- Request - Major Site Plan Review for a New Parking Lot
- Location - 600 Matzinger Road
- Applicant / Owner - Perstorp Polyols Toledo
600 Matzinger Road
Toledo, OH 43612
- Civil Engineer - Wade Trim Associates, Inc.
2851 Charlevoix Drive SE, Suite 108
Grand Rapids, MI 49546

The staff recommends that the Toledo City Plan Commission approve SPR26-0006, a Major Site Plan Review for a New Parking Lot at 600 Matzinger Road, for the following two (2) reasons:

MAJOR SITE PLAN REVIEW
TOLEDO CITY PLAN COMMISSION
REF: SPR26-0006
DATE: March 12, 2026
TIME: 2:00 P.M.

SITE PLAN

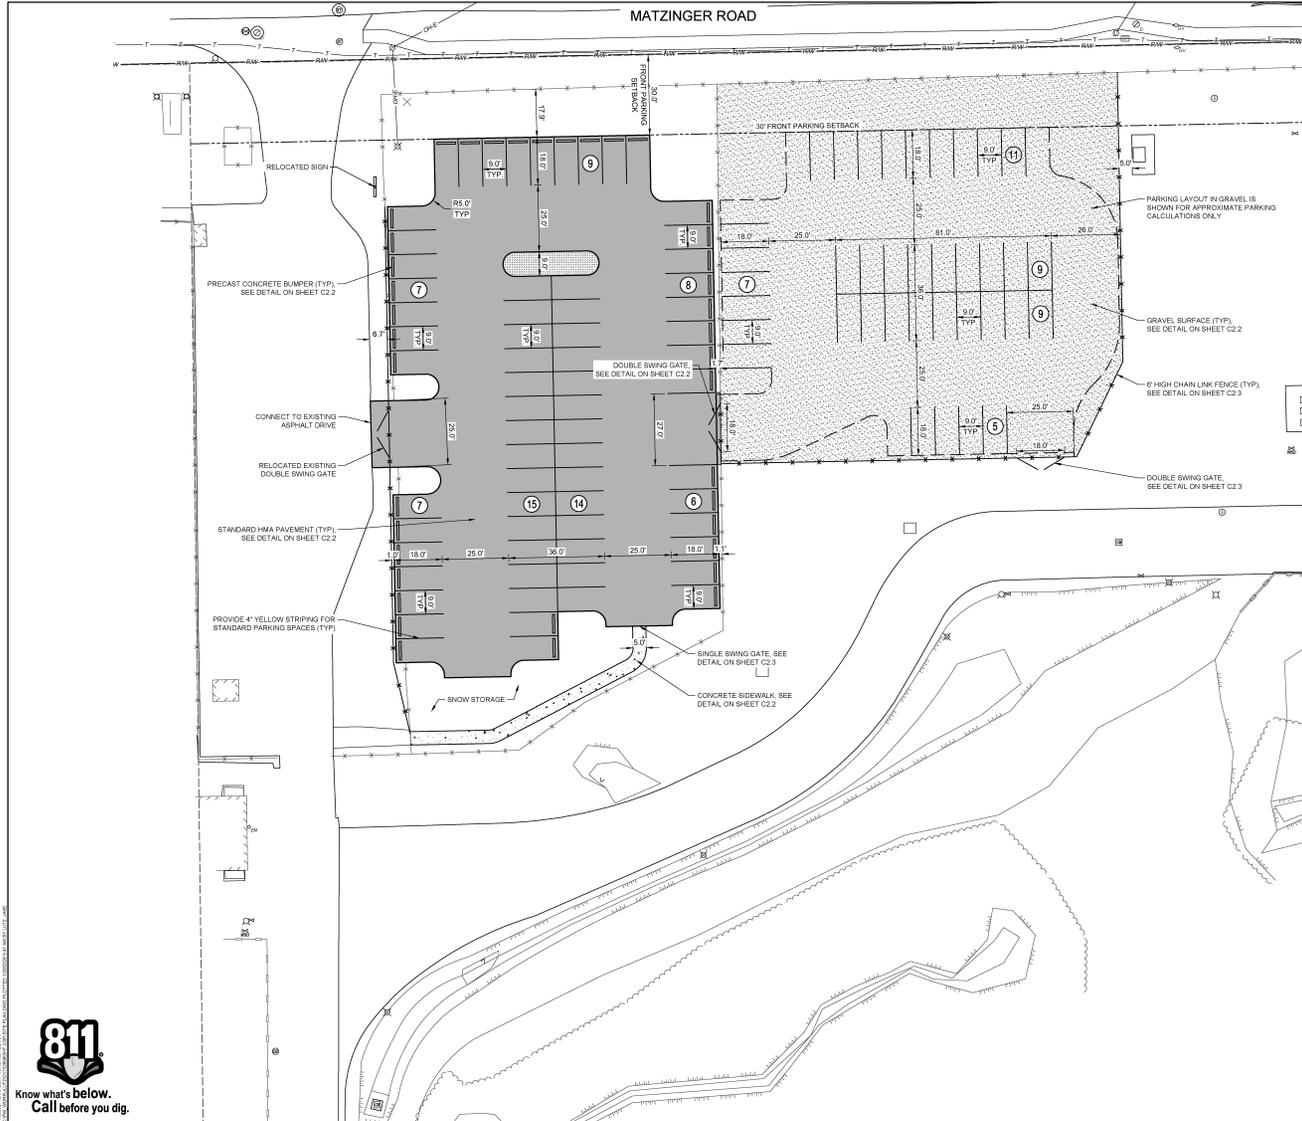
TMC§1107.1906 *Surfacing and Drainage* requires all off-street parking and loading areas, parking lots, maneuvering areas, aisles, and driveways to be surfaced with concrete, bituminous asphalt, or other dust-free material other than gravel or loose fill. The eastern portion of the proposed parking lot would be made of gravel. The applicant is requesting a variance from this requirement for this portion of the parking lot because it would be used only twice a year during shutdown periods – occurring in the fall and spring. The applicant will need to obtain a variance from the Board of Zoning Appeals (BZA). Staff is not supportive of this variance. If the Board of Zoning Appeals denies this variance the applicant will be required to submit a revised site plan depicting all parking lots surfaced with concrete, bituminous asphalt, or other dust-free material. This has been added as a condition of approval.

With 173 parking spaces proposed, TMC§1107.1700 *Accessible Parking for Physically Disabled Persons* requires a minimum of one (1) van- and five (5) auto-accessible parking spaces on this site. There are currently two (2) van-accessible and three (3) auto-accessible spaces on site; however, none are depicted. The applicant shall submit a revised site plan depicting a number of accessible parking spaces on site in compliance with TMC§1107.1700 and the Americans with Disabilities Act.

TMC§1107.0900 *Bicycle Parking* requires a minimum of one (1) bicycle parking space for every ten (10) vehicle parking spaces. None are currently depicted. The applicant shall submit a revised site plan depicting a minimum of one (1) bicycle parking space for every ten (10) vehicle parking spaces on this site. This has been added as a condition of approval.

15. Bicycle parking is required per TMC§1107.0900. **Not acceptable as depicted. Applicant shall submit a revised site plan depicting one (1) bicycle parking space for every ten (10) vehicle parking spaces. Bicycle parking spaces shall meet the standards of TMC§1107.0900.**
16. Five (5) auto and one (1) van accessible parking with 5' loading aisle for auto and 8' loading aisle for van is required per TMC§1107.1701 & 1107.1702. **Not acceptable as depicted. The applicant shall submit a revised site plan depicting all accessible parking spaces on site and ensuring compliance with TMC§1107.1701 & 1107.1702.**
17. All off-street parking, loading spaces, parking lots, maneuvering areas, drive aisles and driveways must be surfaced with concrete, asphalt or other dust free material other than gravel or loose fill per TMC 1107.1906.

18. Per TMC§1107.1906 *Surfacing and Drainage*, off-street parking and loading spaces, parking lots, maneuvering areas, aisles and driveways must be surfaced with concrete, bituminous asphalt, or other dust-free material other than gravel or loose fill. **Not acceptable as depicted. The applicant shall either obtain a variance from the Board of Zoning Appeals or submit a revised site plan showing compliance with TMC§1107.1906.**

LANDSCAPE PLAN

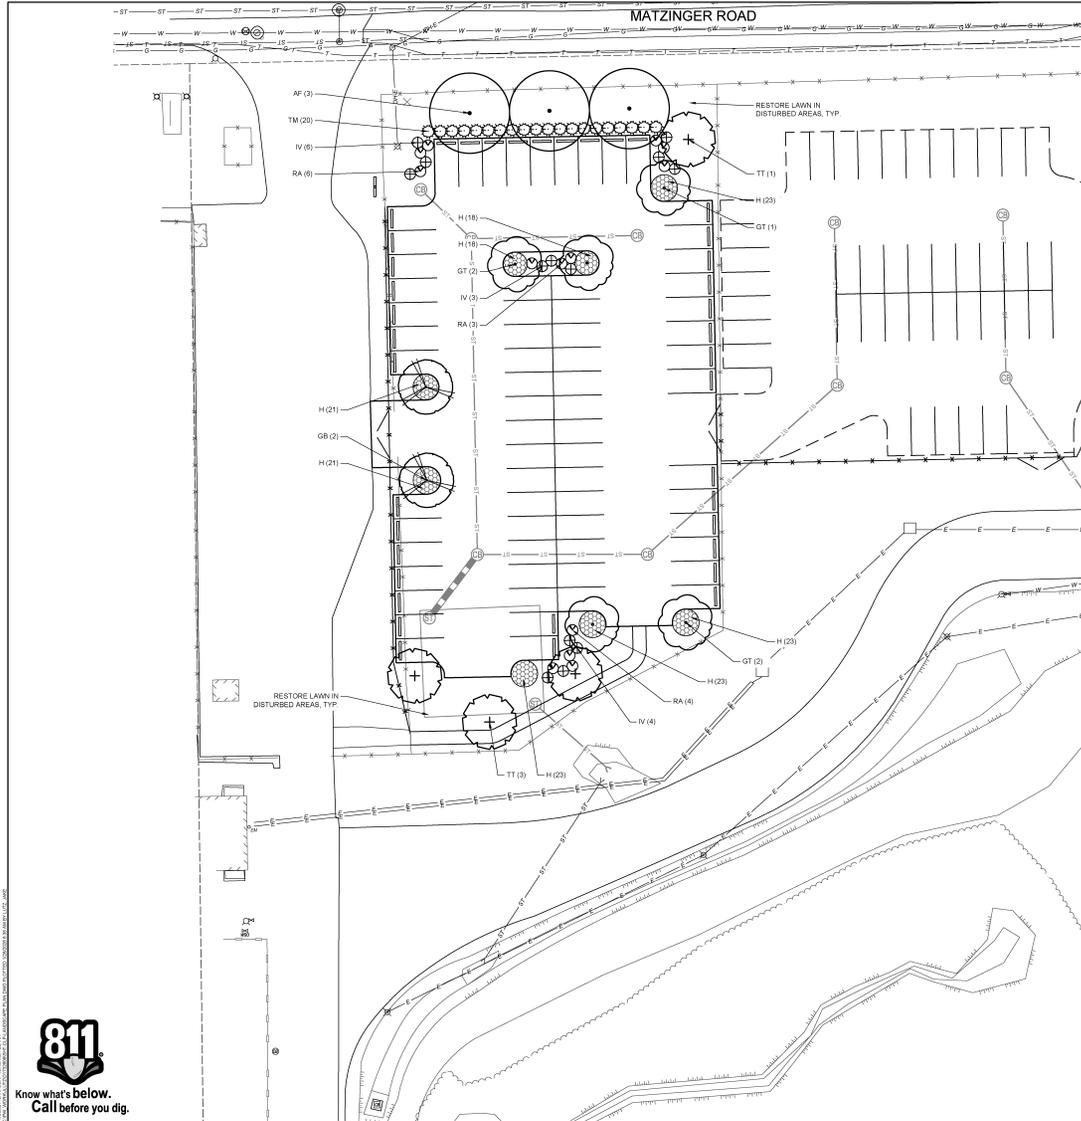
TMC§1108.0202 *Frontage Greenbelt* requires a minimum thirty-foot (30') wide frontage greenbelt along Matzinger Road. This greenbelt must contain at least one (1) tree for every thirty linear feet (30') of frontage and a solid evergreen hedge planting. SPR-47-23, a Minor Site Plan Review for a New Industrial Building and Parking Lot at 632 Matzinger Road, was approved on March 8, 2024 and included a final landscape plan approved on March 14, 2024. This landscape plan depicted trees along the Matzinger Road frontage greenbelt adjacent to this proposed parking lot. A site visit on February 24, 2026 showed that most but not all of these trees were planted. The applicant shall submit a revised landscape plan depicting currently-planted trees and ensuring that a minimum of one (1) tree is planted for every thirty linear feet (30') within the frontage greenbelt adjacent to the proposed parking lot. This has been added as a condition of approval.

TMC§1108.0204 *Parking Lot Landscaping* would require landscape terminal islands and a quantity of interior parking lot plantings; however, per TMC§1108.0204(A)(2) these standards do not apply to parking lots within a General Industrial (IG) district not abutting a residential use. The applicant's proposed terminal islands and parking lot landscaping is acceptable as depicted.

19. Per TMC§1108.0202 *Frontage Greenbelt*, a minimum of one (1) tree is required within the frontage greenbelt along Matzinger Road for every thirty feet (30') of lot frontage. **Not acceptable as depicted. The applicant shall submit a revised landscape plan depicting all existing trees within the Matzinger Road frontage greenbelt and ensuring a minimum of one (1) tree for every thirty feet (30') of lot frontage adjacent to the proposed site improvements.**
